PLANS AND DOCUMENTS referred to in the PDA DEVELOPMENT APPROVAL

Approval no: DEV2016/759
Date: 25 January 2017

AMENDED IN RED

527 GREGORY TCE

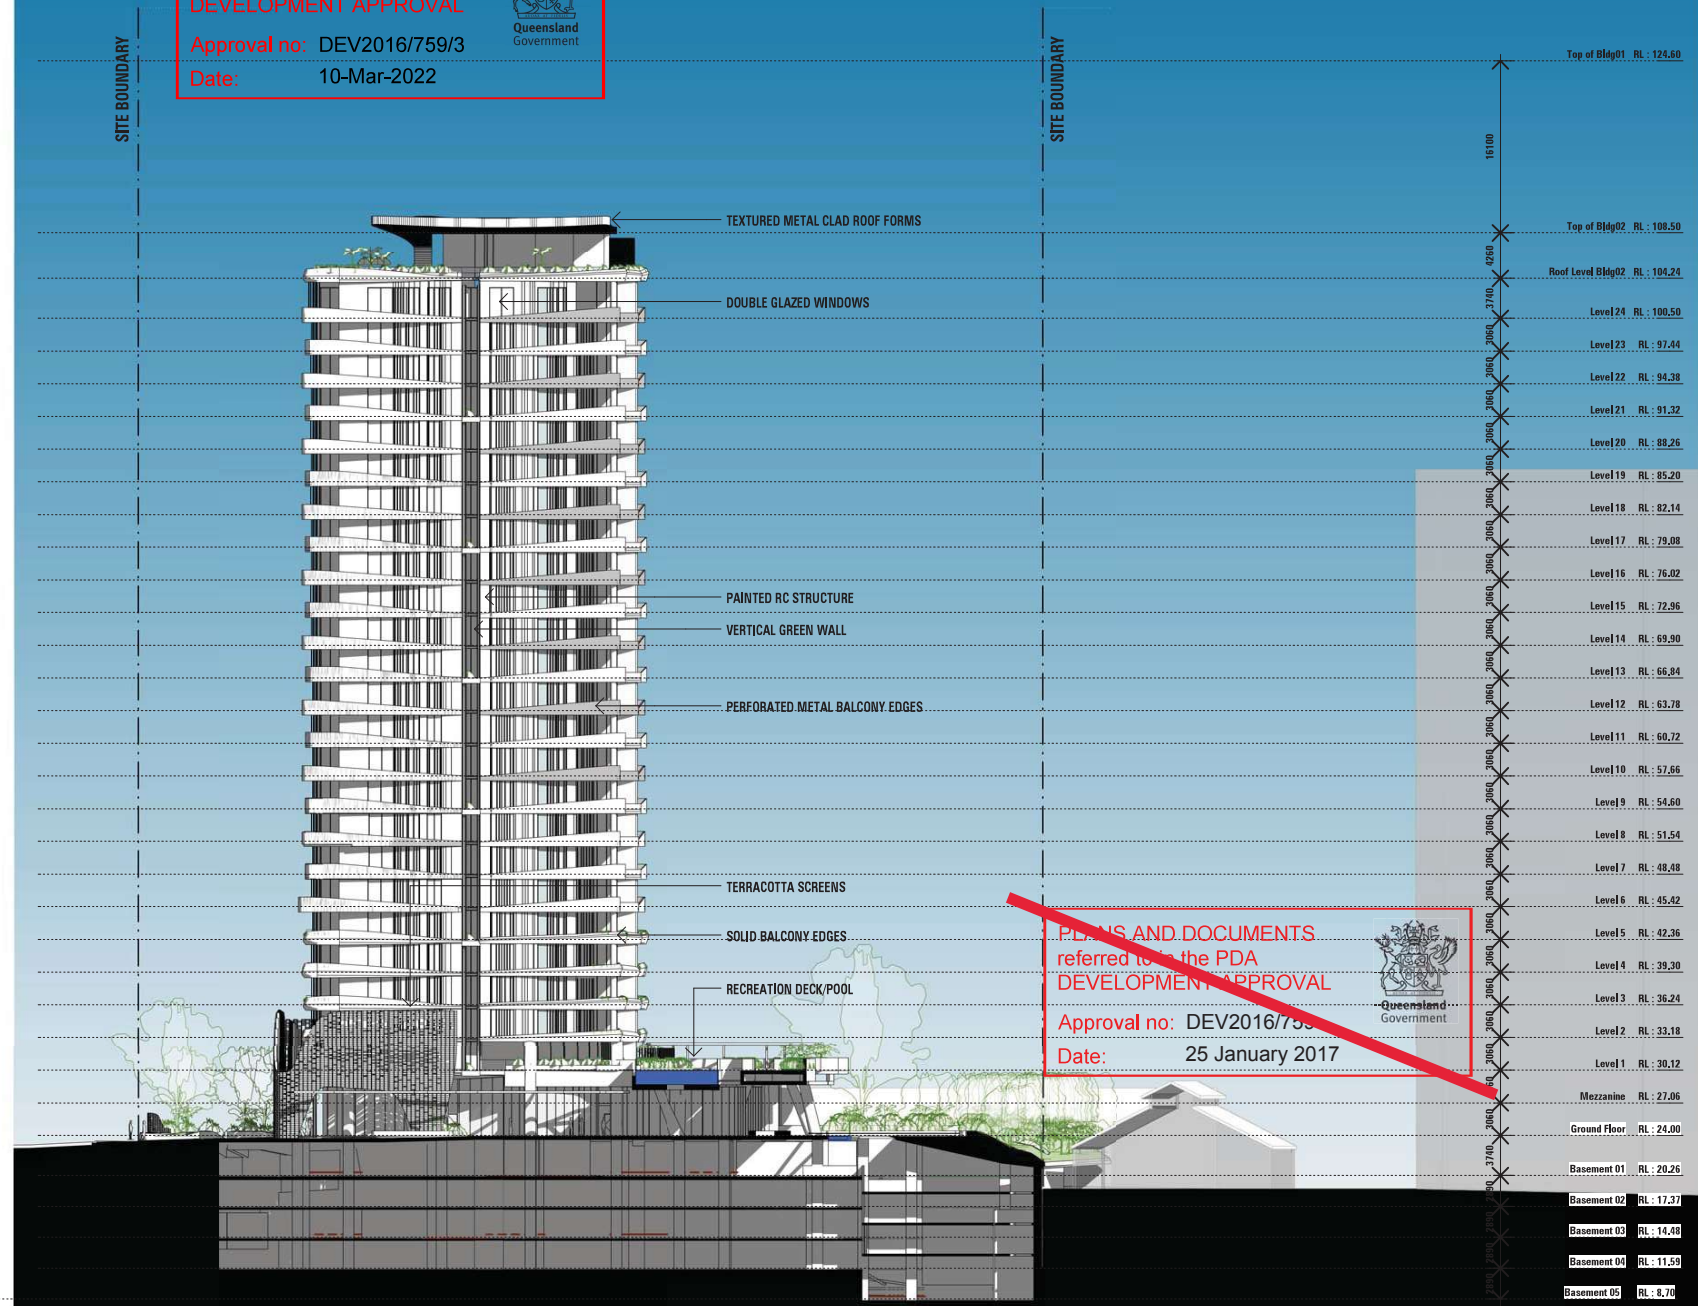
Increase building
setback to 9m from
boundary.
Reconfigure
apartments /
building design to
achieve setback.

SECTIONS TOWER 1

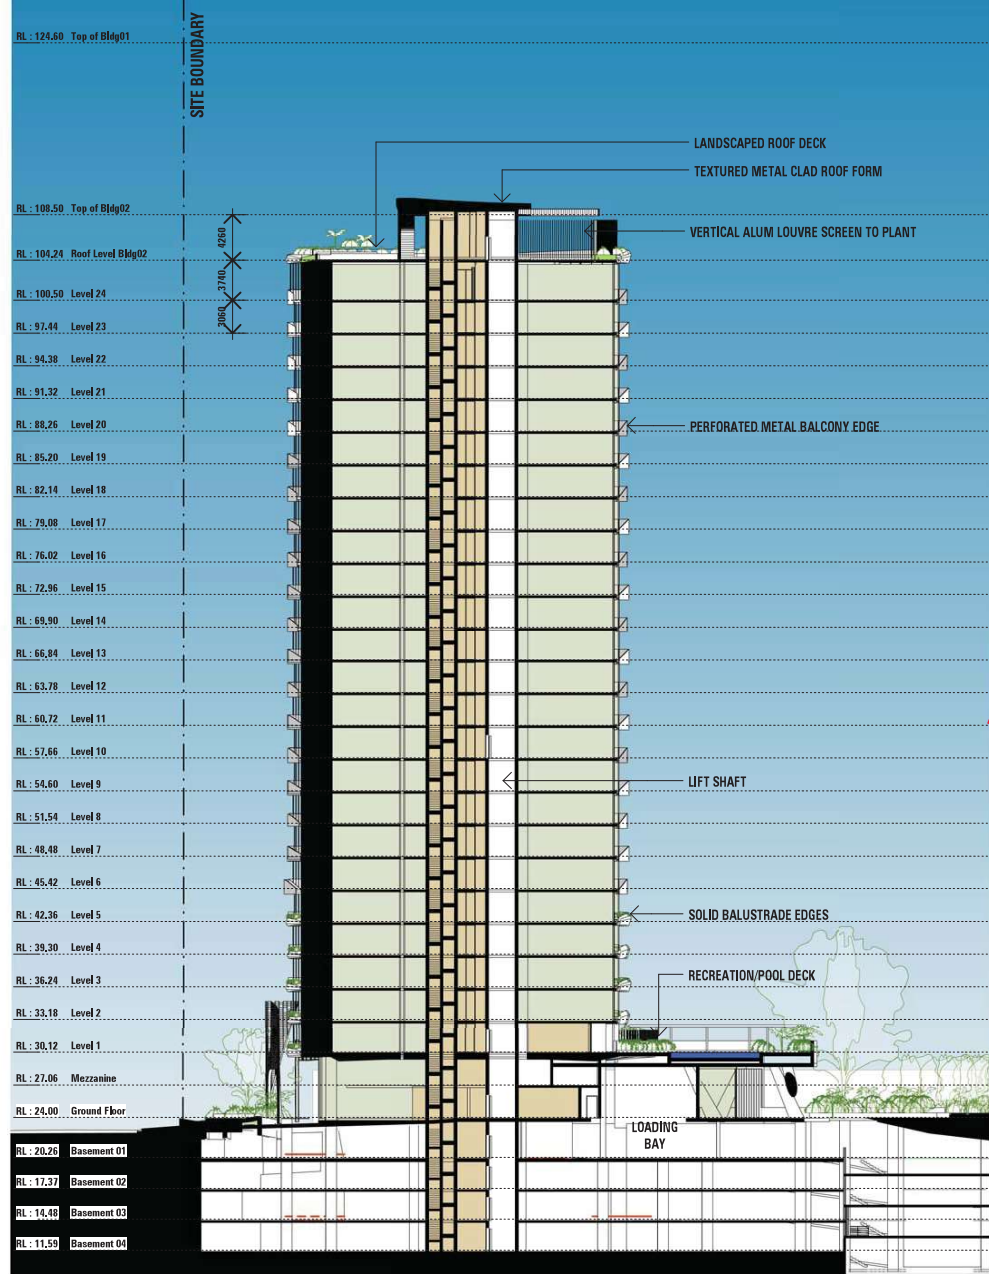
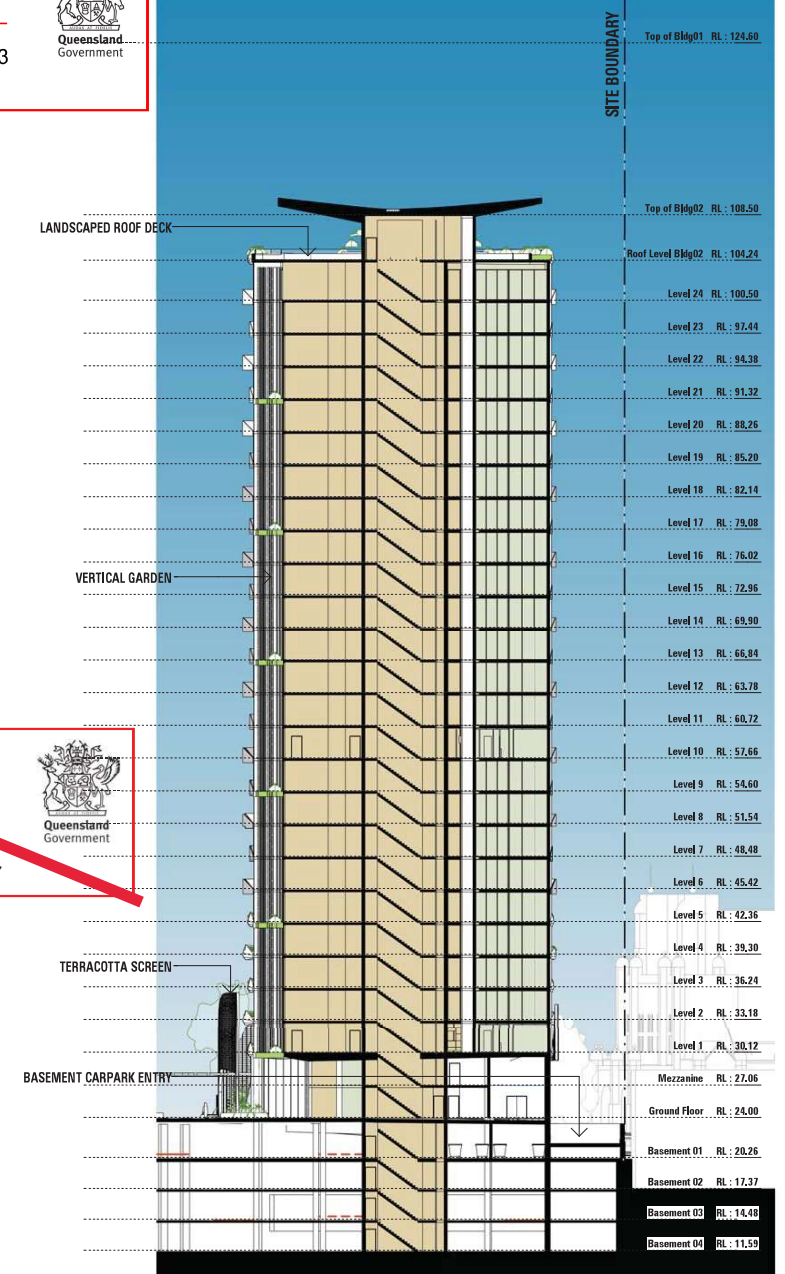
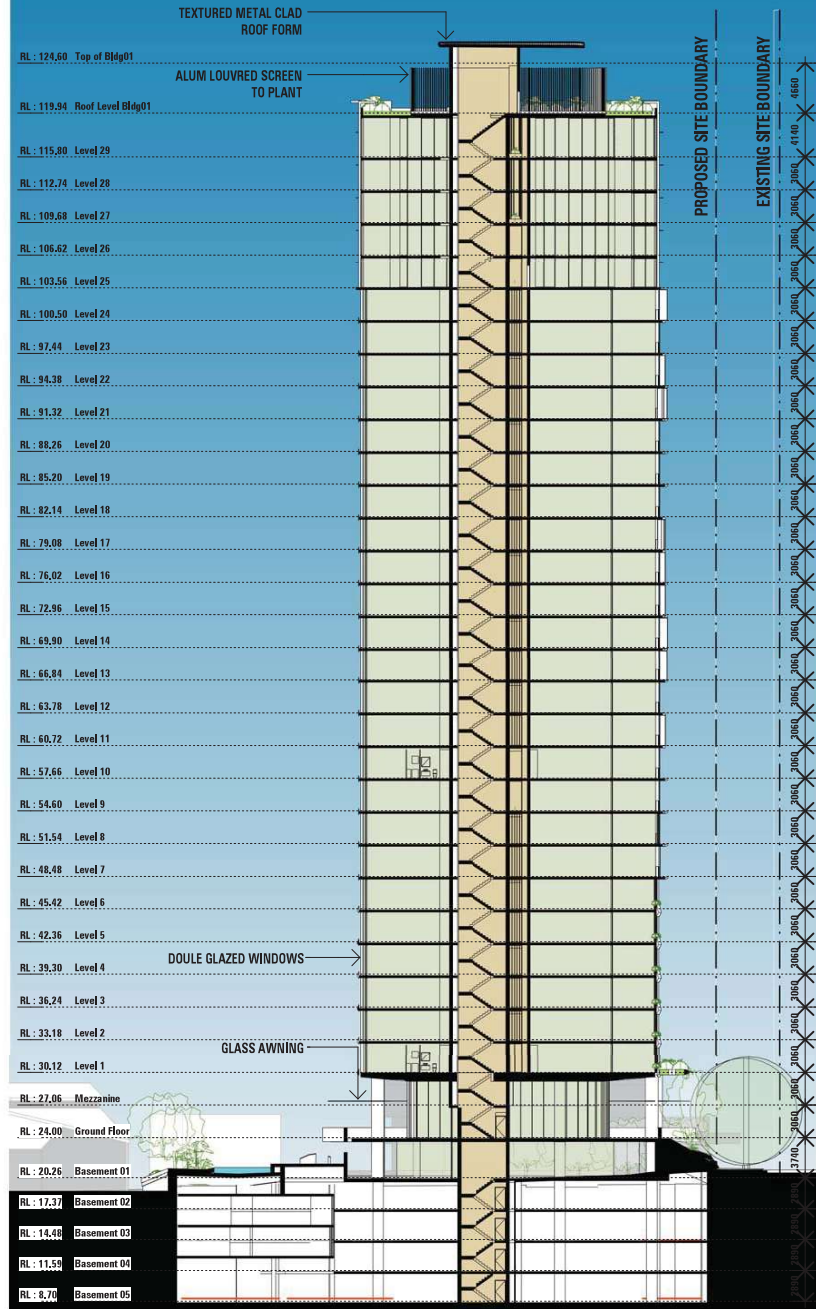
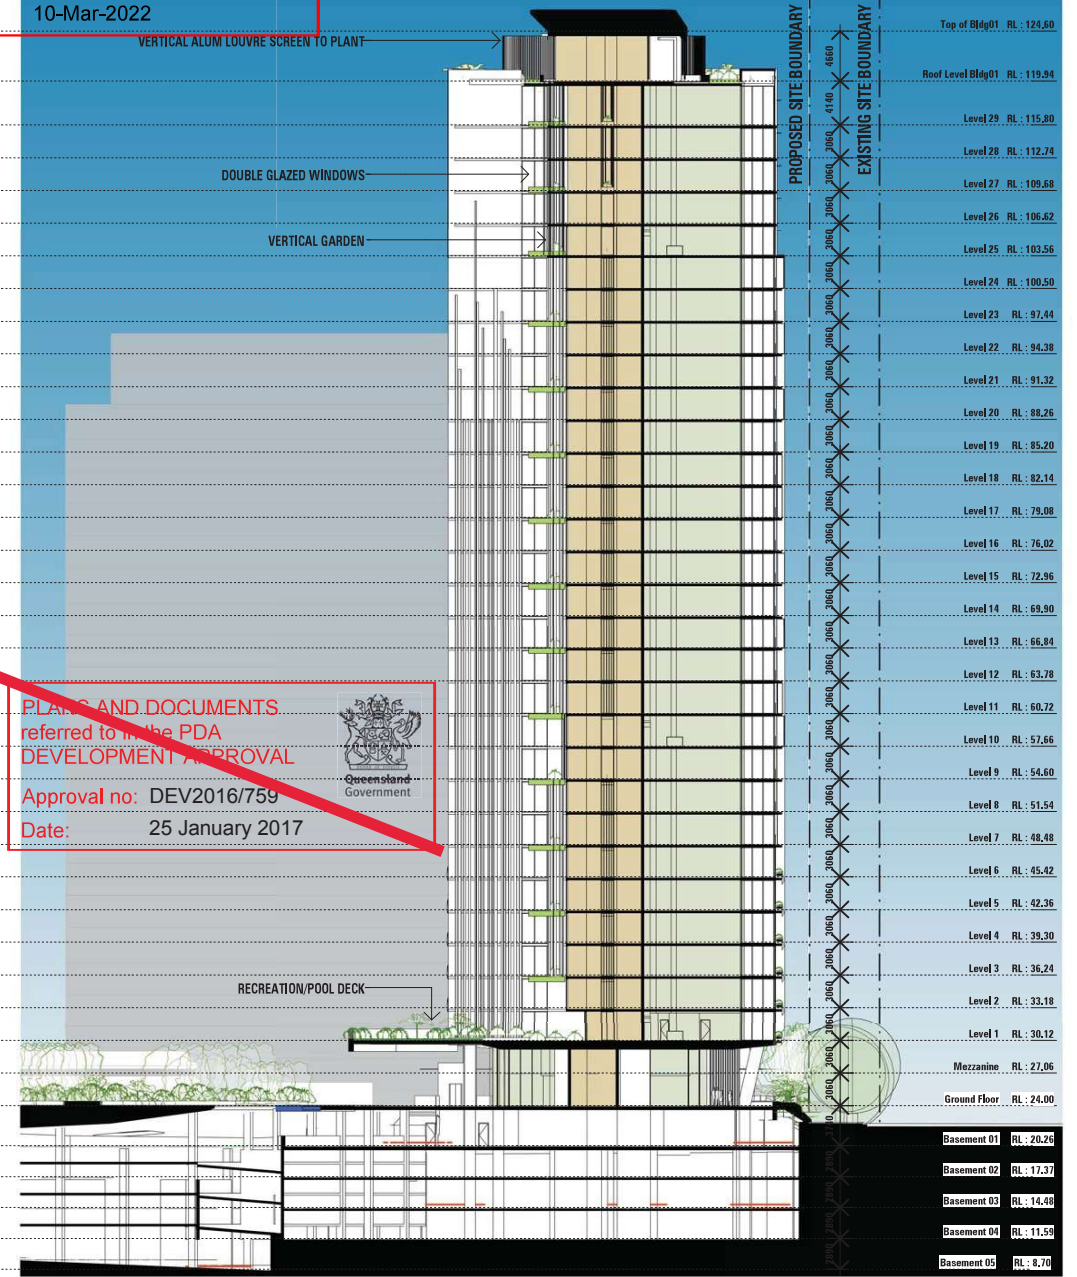
Increase building
setback to 9m from
boundary.
Reconfigure
apartments /
building design to
achieve setback.

TOWER 02 - NORTH WEST SCREENS / SUN SHADING

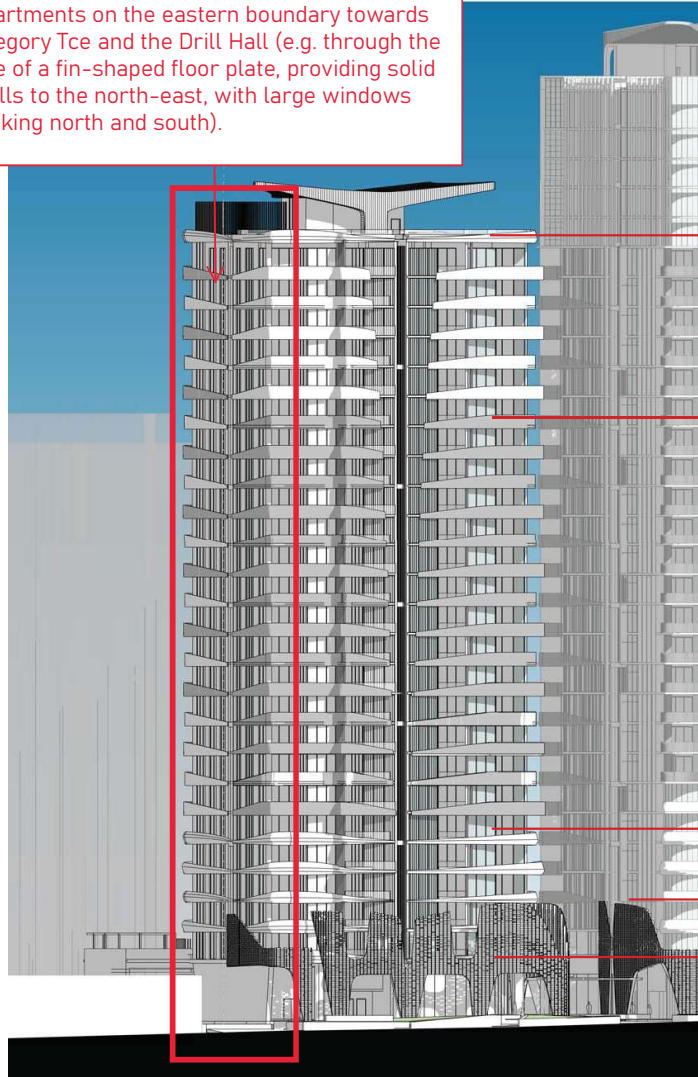
Reconfigure outlook of habitable spaces of all apartments on the eastern boundary towards Gregory Tce and the Drill Hall (e.g. through the use of a fin-shaped floor plate, providing solid walls to the north-east, with large windows looking north and south).

NOTE:
FACADE TREATMENT REMAINS THE SAME ON EASTERN EDGES

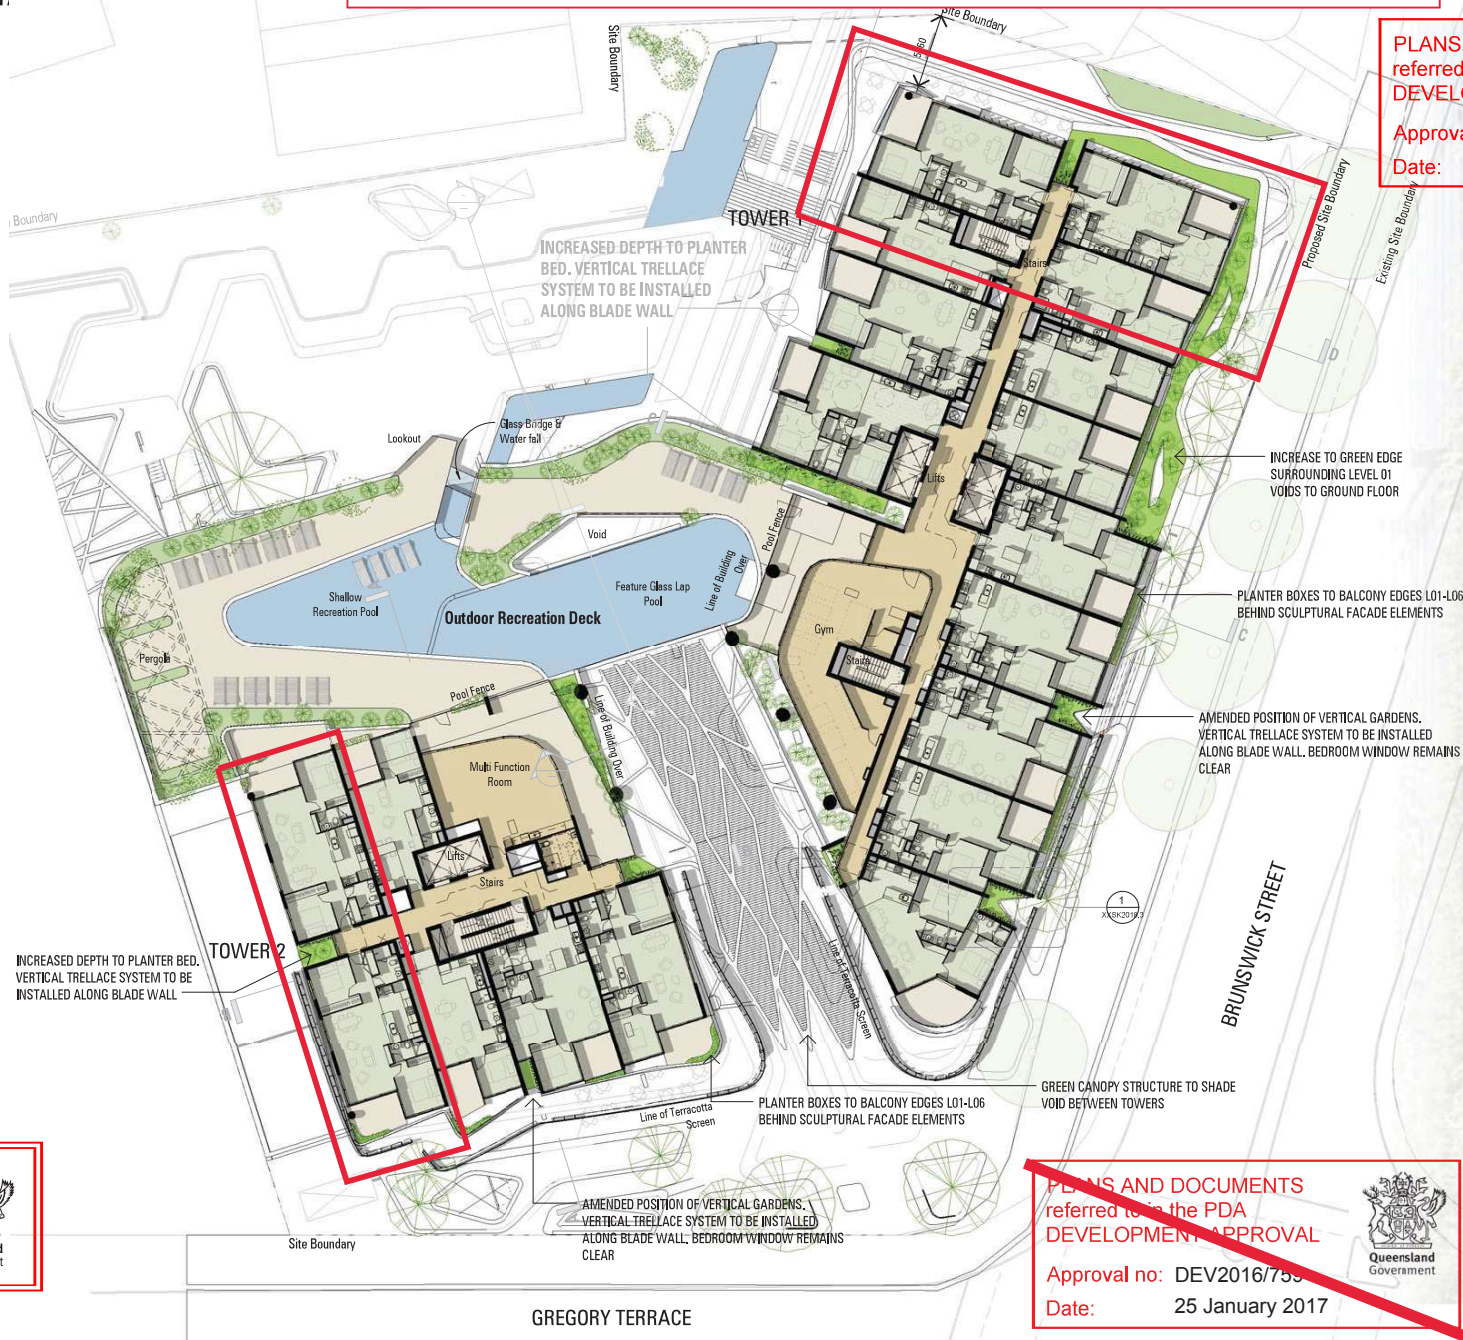
Detailed landscape architecture plans to be submitted, supported by details demonstrating the ability to establish and maintain the proposed vertical gardens, having regard for planter depths, soil/media volumes, irrigation and maintenance systems, access to light, and choice of appropriate species.

1. A VERTICAL TRELLIS SYSTEM IS PROPOSED TO BE FIXED ALONG THE BLADE WALL OF EACH RECESS. THEREFORE LEAVING A CLEAR OPENING TO THE BEDROOM WINDOW. THE PLANTING WIDTH HAS INCREASED AND WILL NOW BE MORE VISIBLE ALONG THE ELEVATION.

2. AN IRRIGATION SYSTEM IS PROPOSED TO MAINTAIN THE INTEGRITY OF THE PLANTING ACROSS THE SCHEME. DETAILS TBA

3. LEVEL 01 INCLUDES AN INCREASED GREEN EDGE TO EXTEND OVER THE RETAIL WALKWAY BELOW. THIS DENSELY VEGETATED GREEN EDGE WILL PROVIDE GREATER PROTECTION AND ADDRESS THE REQUIREMENT FOR AN EXTENSIVELY "GREEN" BUILDING

4. THE SIZE OF ALL PLANTERS HAS BEEN INCREASED TO PROVIDE MAXIMUM VEGETATION WHERE POSSIBLE.

5. PLANTER BOXES ARE PROPOSED ALONG BALCONY EDGES FROM L01- L06 TO ENHANCE THE GREEN AESTHETIC AND FACADE PERFORMANCE. THESE ARE TO BE MAINTAINED BY RESIDENTS AND ARE INCLUDED IN THE APARTMENT DESIGN ON THE LOWER LEVELS.

6. THE FEATURE SCREEN WILL INCLUDE CLIMBING VEGETATION AT GROUND TO PROVIDE A SOFT EDGE TO THE DEVELOPMENT. THIS UNIQUE SUBTROPICAL STRUCTURE WILL BE THE KEY LANDMARK OF THE DEVELOPMENT CREATING A DISTINCT GATEWAY TO THE SITE.

08 & 09 VERTICAL GARDENS

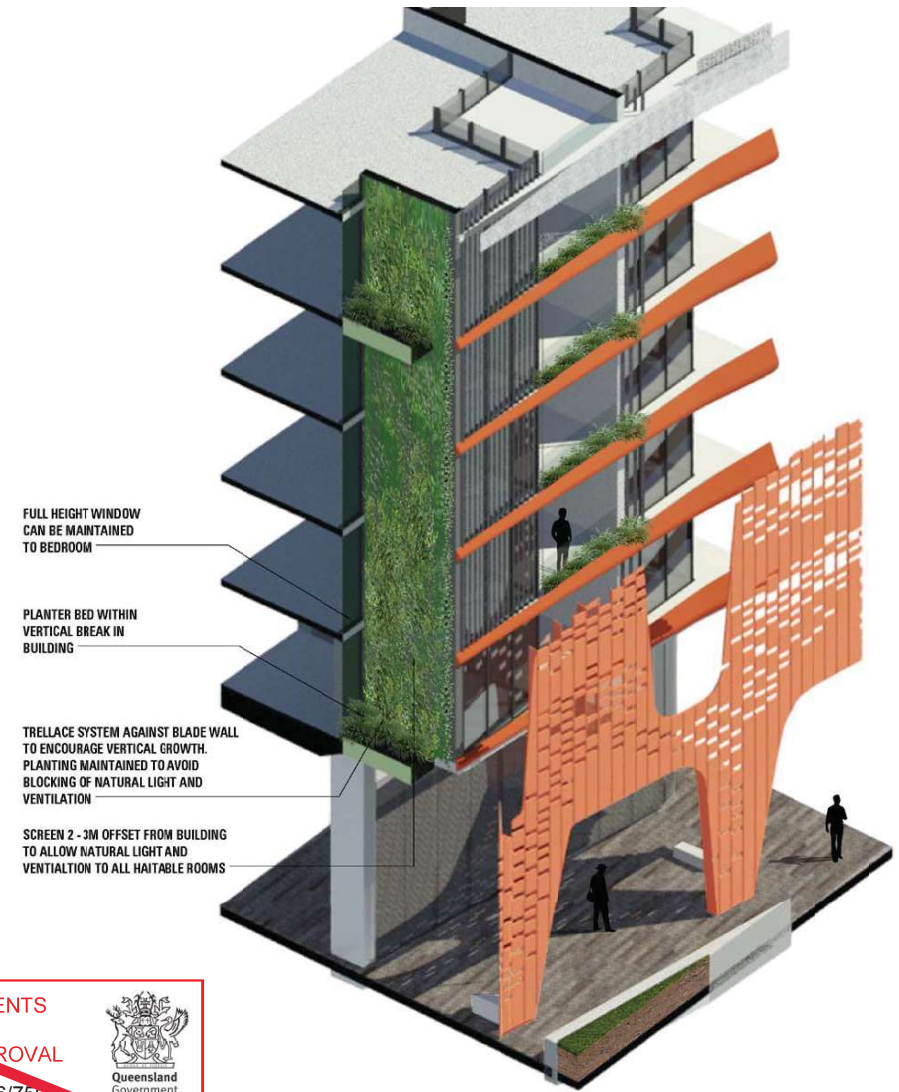
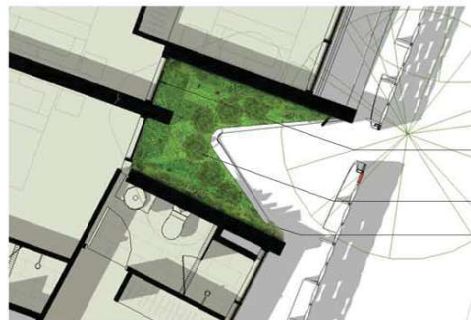
Detailed landscape architecture plans to be submitted, supported by details demonstrating the ability to establish and maintain the proposed vertical gardens, having regard for planter depths, soil/media volumes, irrigation and maintenance systems, access to light, and choice of appropriate species.

A VERTICAL TRELLIS SYSTEM IS PROPOSED EVERY 3 LEVELS TO ENCOURAGE SUFFICIENT GROWTH FROM EACH PLANTER BED. THE VEGETATION IS TO BE MAINTAINED EXTERNALLY VIA ABSIL OR SIMILAR SYSTEM TO PROVIDE SAFE ACCESS FOR MAINTENANCE PERSONNEL TO ACCESS GREEN AREAS AND GLAZING TO PERFORM MAINTENANCE AND CLEANING.
